Flight Procedures Cover Page	Task Action: P-NOTAM	Task Type: IAP	Estimated Chart Date: 12/02/2021	APWS Task ID: C6FC7B7E7261453080D2A2933C37A6B0	APWS Project ID: F1865D9597954204A0DFC461CE56D585
Procedure: VOR RWY 6 AMDT 0B		Enroute: NO	Specialist: Moore, Frank		Agreement Number:
Airport ID: B19			Airport City: BIDDEFORD		State: ME
Facility ID:	Facility Type:	Flight Inspection Remark Type:			
<div>Procedure Comments: P-NOTAM This Cancels FDC 9/1085 and 0/9758 Order 8260.3, chapter 2, New Circling Criteria Applied. CONTACT DAVE TEFFETELLER 202-267-5177</div> <div>QUALITY 9 CHECKED</div> <div>QUALITY 45 CHECKED</div>

FIPC BASIC FORM							
PROCEDURE: VOR RWY 6 AMDT 0B			AIRPORT NAME: BIDDEFORD MUNI		AIRPORT ID: KB19	SPECIAL CONTROL NO: YP-08-189-21	
FAC ID: ENE		CITY: BIDDEFORD			ST: ME	ORIG CHART DATE: 12/02/2021	
DFL TYPE: PROC/A	THIRD PARTY: <input type="checkbox"/> YES	EST. TIME ON SITE: 0.4	REIMB. NUMBER:		PTS TASK ID:		
PREFLIGHT NOTES							
REVIEWER:					DATE:		
COMMENTS:					CHECK ONE:		
					<input type="checkbox"/> FLT CK REQ <input type="checkbox"/> NFCR <input type="checkbox"/> REJECT		
							YES
					CPV COMPLETE?		X
PROCEDURE RESULTS							
INSPECTION DATE: 09/14/202

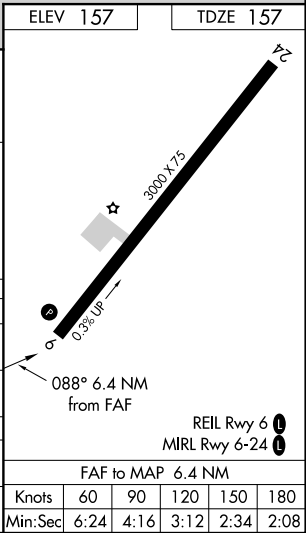
<div>NA</div> <div>Circling Rwy 24 NA at night. Rwy 6 helicopter visibility reduction below ¾ SM NA.</div>	MISSED APPROACH: Climb to 800, then climbing left turn to 2300 direct ENE VOR/DME and hold.
PORTLAND APP CON ★ 119.75 269.35	UNICOM 123.0 (CTAF) 0

VOR RWY 6
BIDDEFORD MUNI (B19)

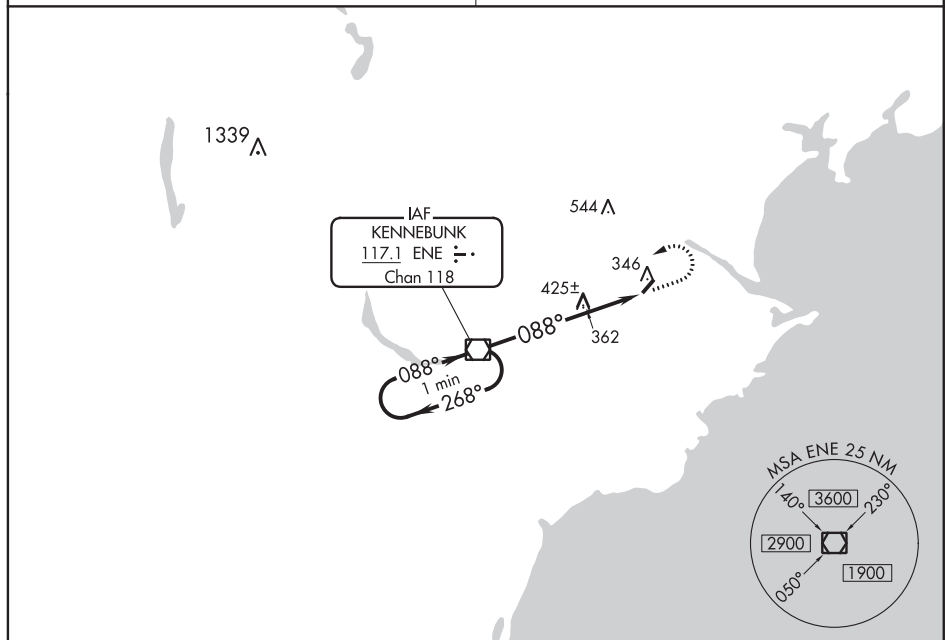
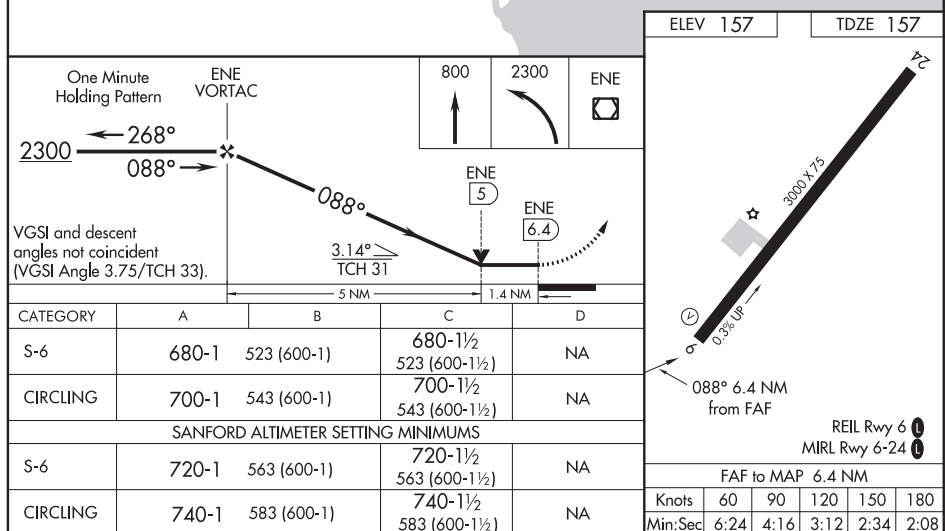
<p>⚠ NA Obtain local altimeter on CTAF; when not received, use Sanford altimeter setting. VDP NA when using Sanford altimeter setting.</p>	<p>MISSED APPROACH: Climb to 800, then climbing left turn to 2300 direct ENE VOR/DME and hold.</p>
<p>PORTLAND APP CON ★ 119.75 269.35</p>	<p>UNICOM 123.0 (CTAF) 0</p>
